**PURPOSE STATEMENT**  
FOR REVISION #5  
THE PURPOSE OF THIS REDLINE IS TO ADD 13,29'x40' BATHROOM EXPANSION TO THE EX. COMMUNITY BUILDING, HANDICAP SPACE, CONCRETE STOOP AND REVISE THE STORMWATER MANAGEMENT FACILITY.

**PURPOSE STATEMENT**  
FOR REVISION #6  
THE PURPOSE OF THIS REDLINE IS TO REPLACE THE EXISTING POOL DECK (TRAINING POOL, ADD STORMWATER FACILITIES & DETAILS.

**PROJECT TITLE:** LOUGHELOW NEIGHBORHOOD CENTER 5TH ELECTION DISTRICT, HOWARD COUNTY  
SUBJECT: M 29 2731, LOT 1, 2, 3

**AS-BUILT SITE PLAN**

SWM AS BUILT SUPPLEMENTAL SHEET  
REVISED SITE DEVELOPMENT PLAN  
LONGFELLOW NEIGHBORHOOD CENTER  
OPEN SPACE LOT 2, SECTION 1, AREA 5  
TAX MAP: 29 PARCEL: 273 15th ELECTION DISTRICT ZONE: N.T.  
HOWARD COUNTY, MARYLAND  
SHEET 4 OF 11

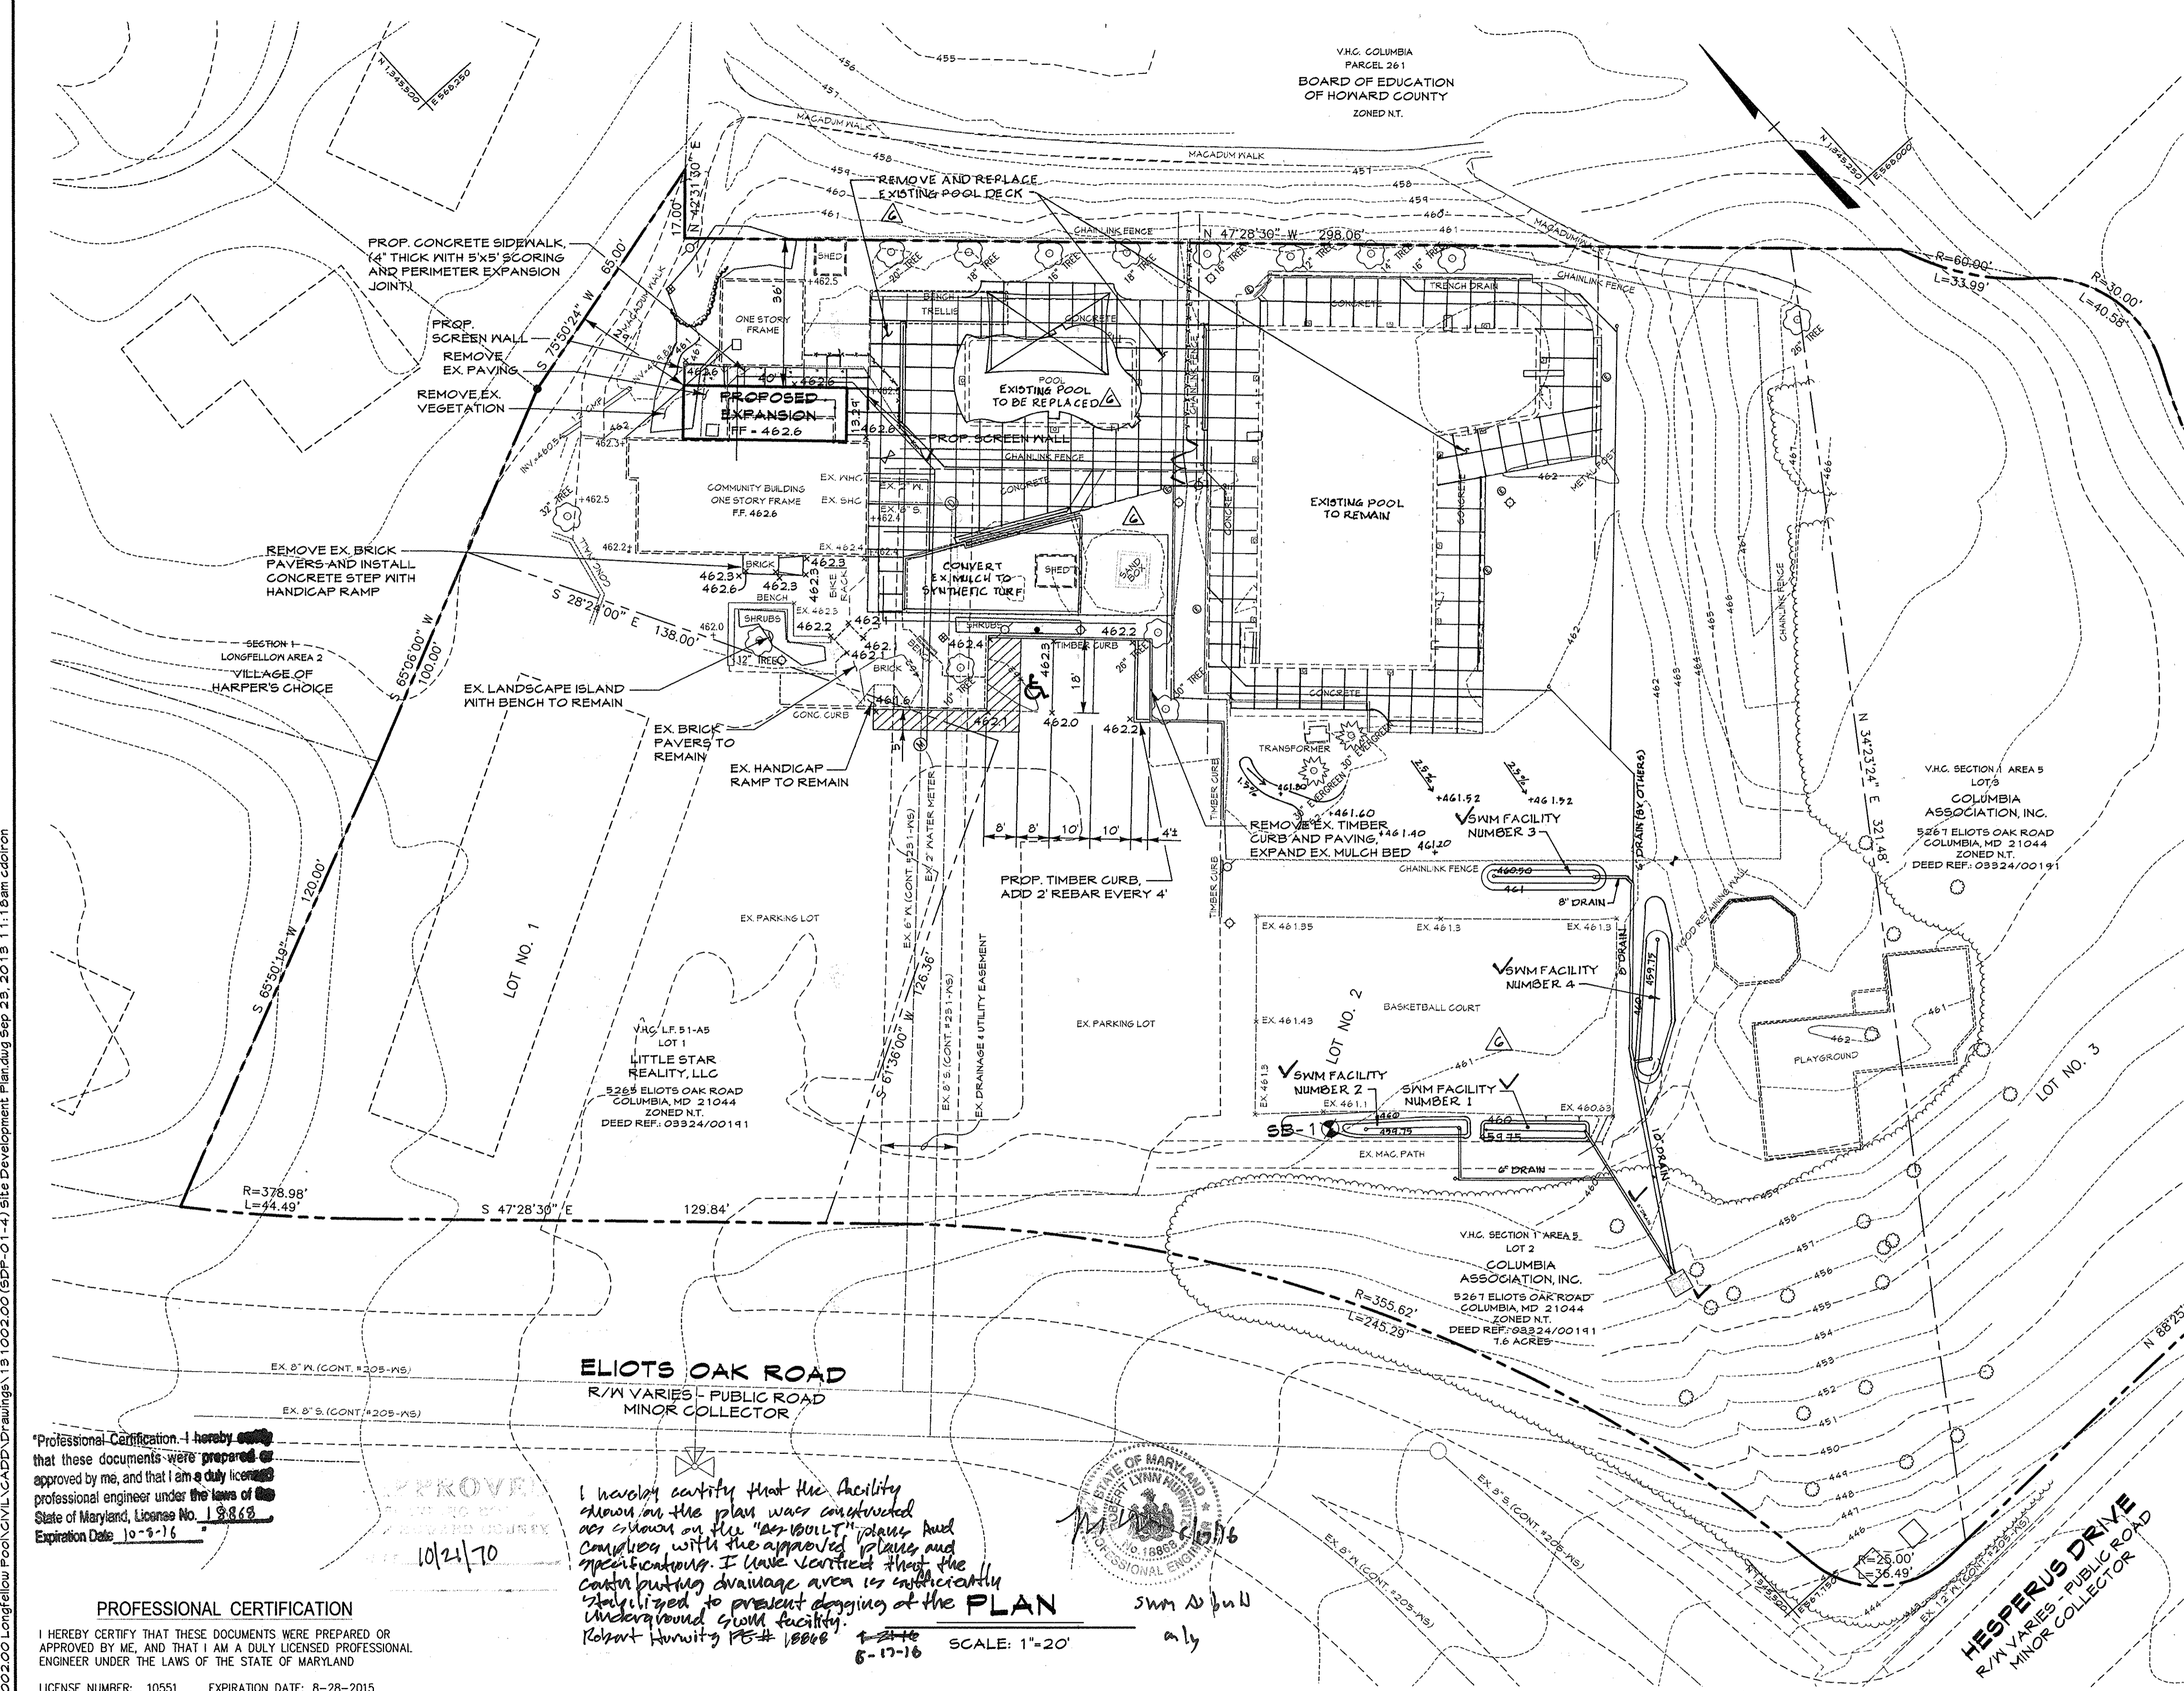
THE PURPOSE OF THIS REDLINE IS TO ADD 13.29' x 40' BATHROOM EXPANSION TO THE COMMUNITY BUILDING, CONCRETE STOOP, STORMWATER MANAGEMENT FACILITY, AND REVISE THE EXISTING HANDICAP PARKING SPACE.

△ PURPOSE STATEMENT FOR REVISION #6  
THE PURPOSE OF THIS REDLINE IS TO REPLACE THE EXISTING POOL DECK & TRAINING POOL, ADD STORMWATER FACILITIES & DETAILS.

**SWM SUPPLEMENTAL SHEET**  
**REVISION EROSION & SEDIMENT CONTROL PLAN**  
 LONGFELLOW NEIGHBORHOOD CENTER  
 OPEN SPACE LOT 2, SECTION 1, AREA 5  
 TAX MAP: 29 PARCEL: 273 15th ELECTION DISTRICT ZONE: N.T.  
 HOWARD COUNTY, MARYLAND  
 SHEET 5 OF 11

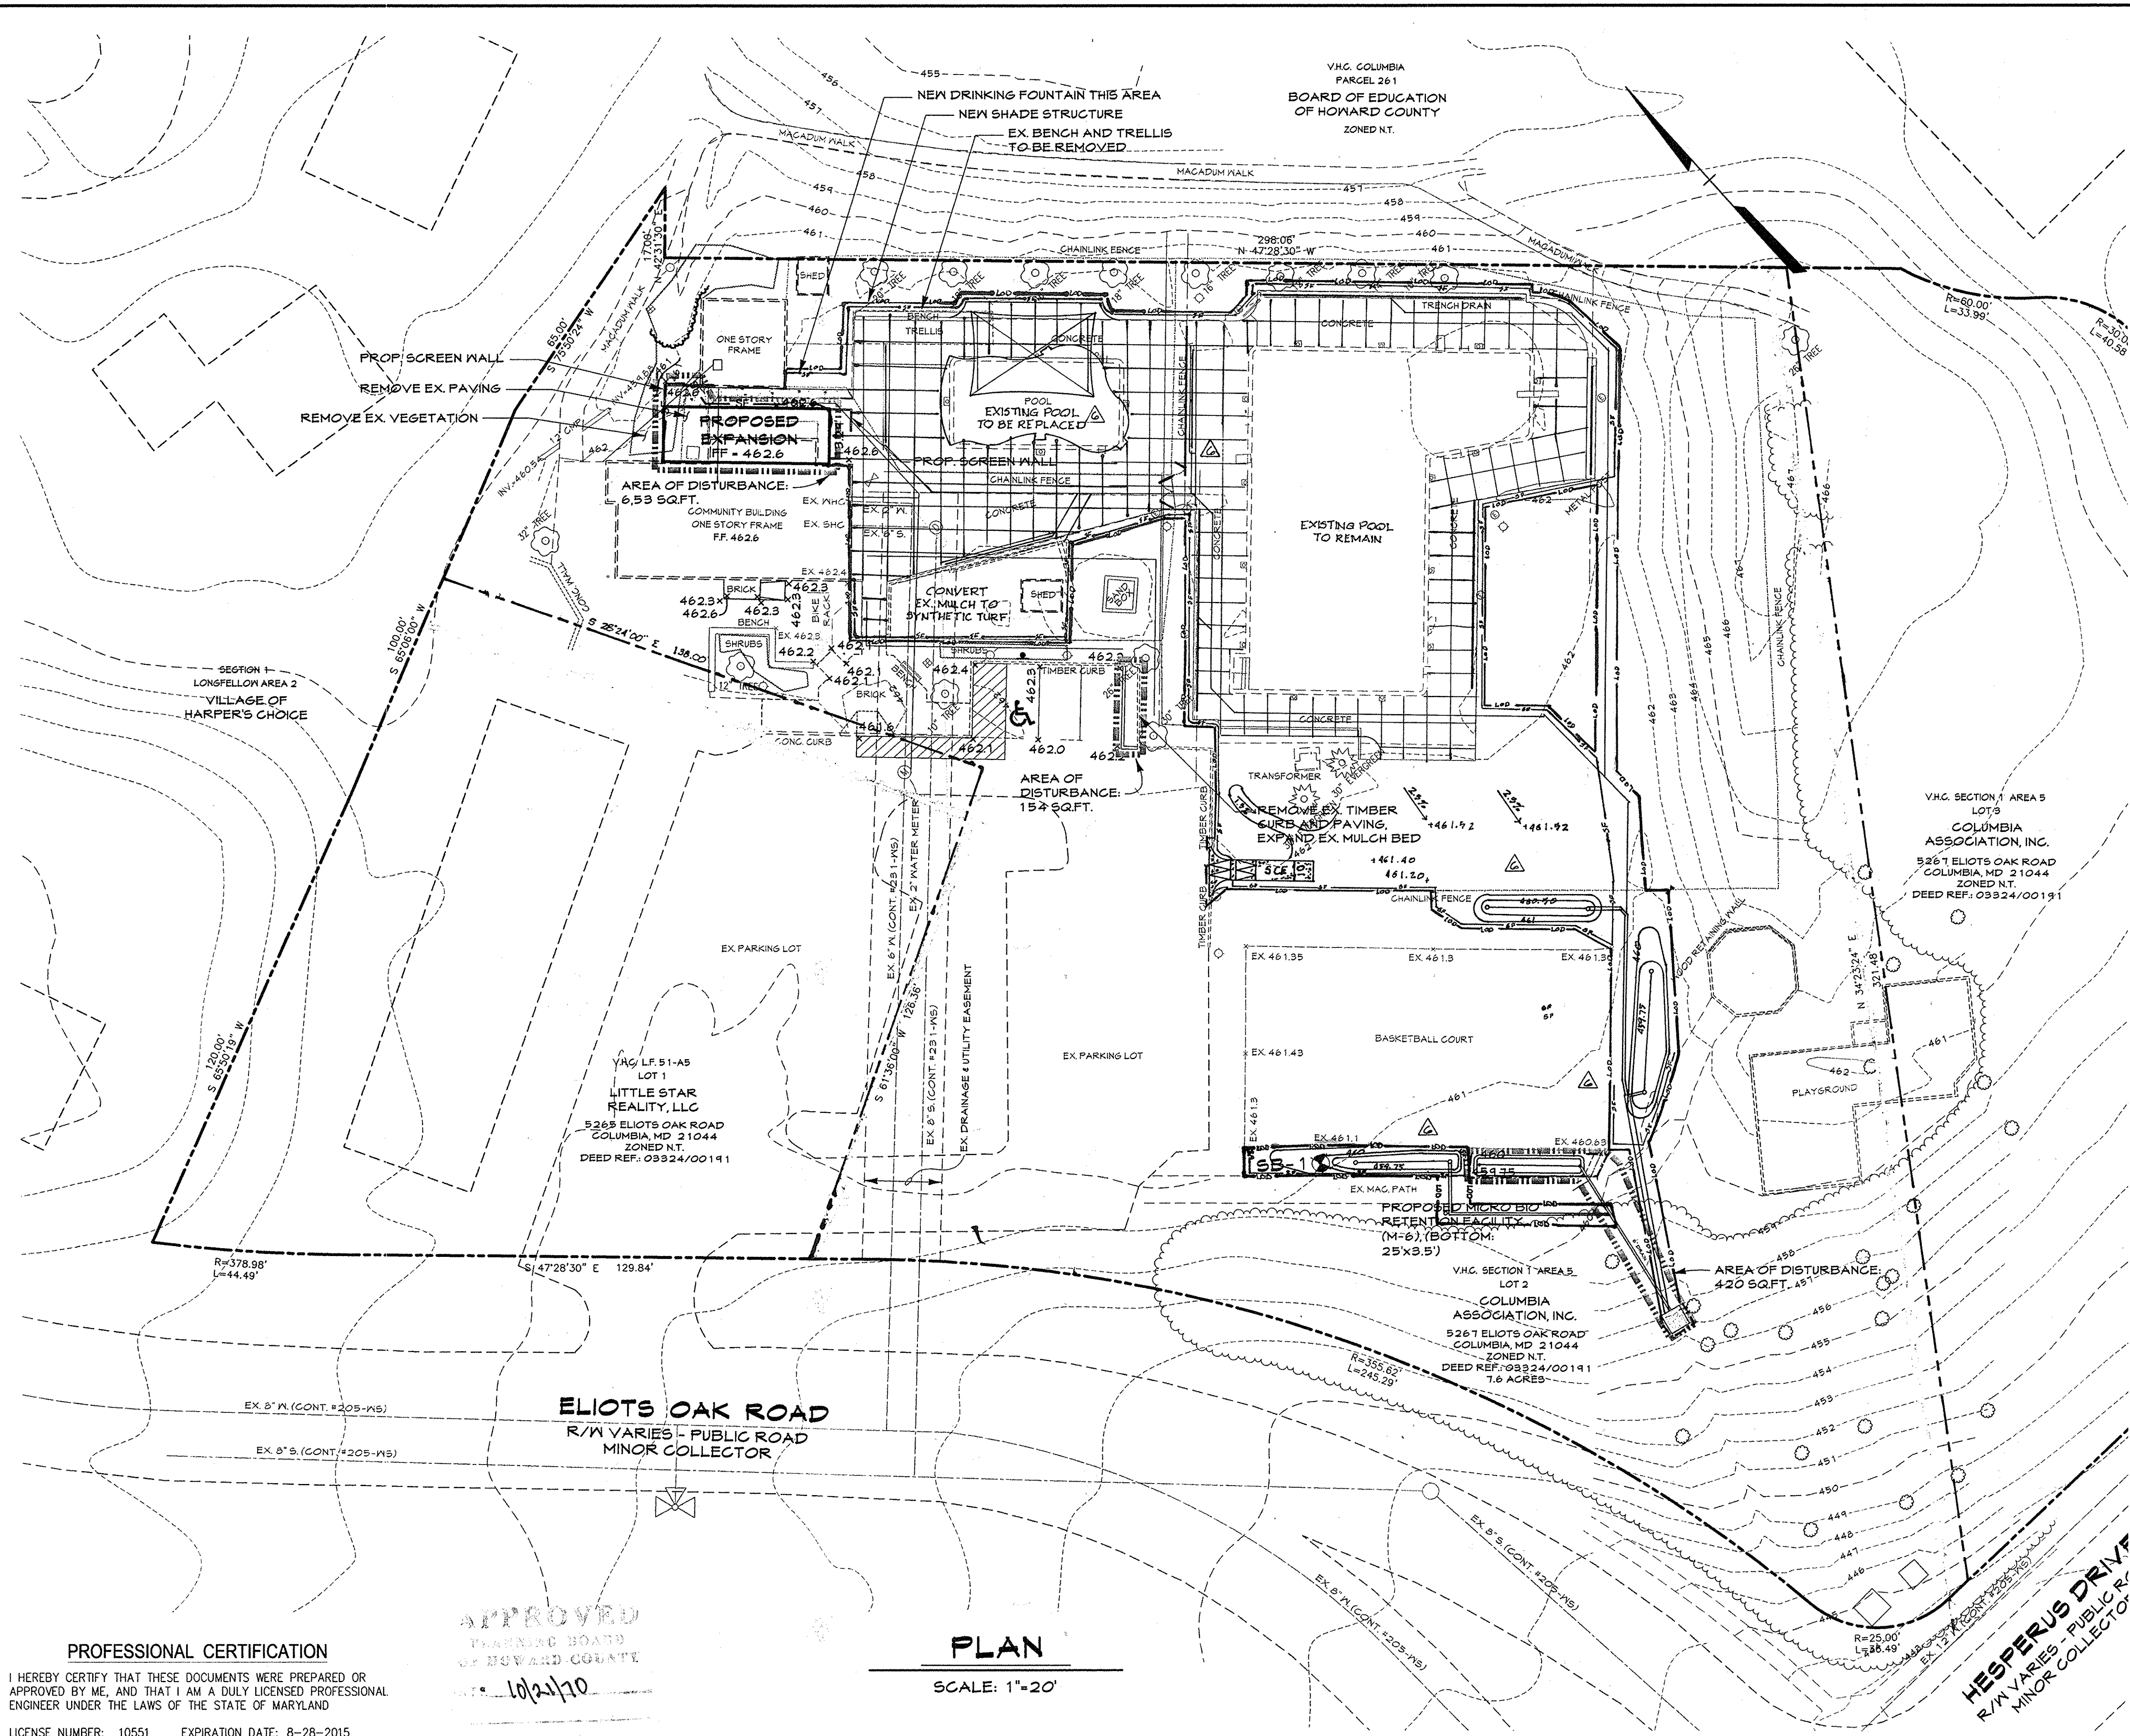
THE PURPOSE OF THIS REDLINE IS TO ADD 13.24' x 40' BATHROOM EXPANSION TO THE COMMUNITY BUILDING, CONCRETE STOOP, STORMWATER MANAGEMENT FACILITY, AND REVISE THE EXISTING HANDICAP PARKING SPACE.

**PURPOSE STATEMENT FOR REVISION #6**  
 THE PURPOSE OF THIS REDLINE IS TO REPLACE THE EXISTING POOL DECK WITH TRAINING POOL, ADD STORMWATER FACILITIES (DETAILS).
